Fuel Filter Replacement Maintenance Schedule Correction - 2010 & 2013 Emission Diesel Engines

UPDATE

Models Affected: Service Maintenance Manuals (A3FE, A3RE, D3FE, D3RE for 2010 – 2014; BBCV for 2011 – 2014 and T3FE and T3RE for 2014) and Driver’s Hand Book (A3FE, A3RE, D3FE, D3RE for 2011 – 2014; BBCV for 2012 – 2014; T3FE and T3RE for 2014) which list a mileage only for fuel filter replacement for diesel engines.

EXAMPLE FROM 2014 DRIVER’S HAND BOOK

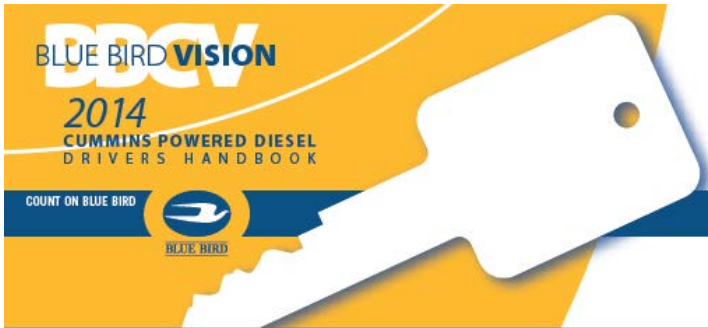
Please update your Service Maintenance Manuals and Driver Hand Books by marking through or removing the information that states “Replace Fuel Filter “under the 60,000 Miles header section in the SPECS and MAINTENANCE with no time frame listed.

MARK THROUGH AND/OR DELETE

Every 60,000 Miles
Fuel System
Replace Fuel Filter

Please follow the existing section with Header “Every 6 Months or 6,000 Miles” Subtopic “Fuel Systems” states “Replace Fuel Filter Element”

USE THE FOLLOWING SCHEDULE

Every 6 Months or 6000 Miles
Fuel System
Replace Fuel Filter Filter Element
Clean Fuel Filter Inlet Screen Clean. Replace if damaged.
